- A. Transom Cutout and Steering Lever Interference
- B. Bell Housing to Drive Shaft Housing Studs

A. TRANSCOM CUTOUT and STEERING LEVER INTERFERENCE

B. BELL HOUSING to DRIVE SHAFT HOUSING STUDS

Figure 1. Typical Transom Cutout

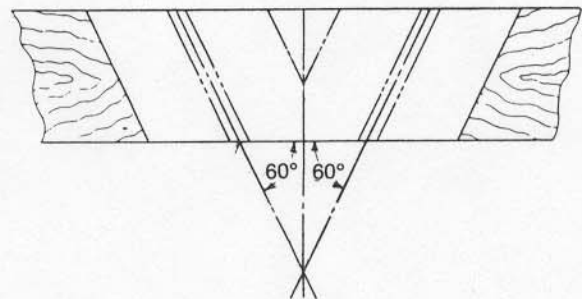
The top corners of the transom cutout on all MerCruiser Stern Drives (Figures 1 and 2) must be cut at angle specified in appropriate model "Stern Drive Installation Manual". If cut at other than specified angle, steering lever can contact transom and limit steering and/or cause hard steering.

If Power Steering is used (because drive unit travel stops before Power Steering travel stops), pump lugging in a tight turn possibly could cause damage to Power Steering system and render Power Steering inoperable.
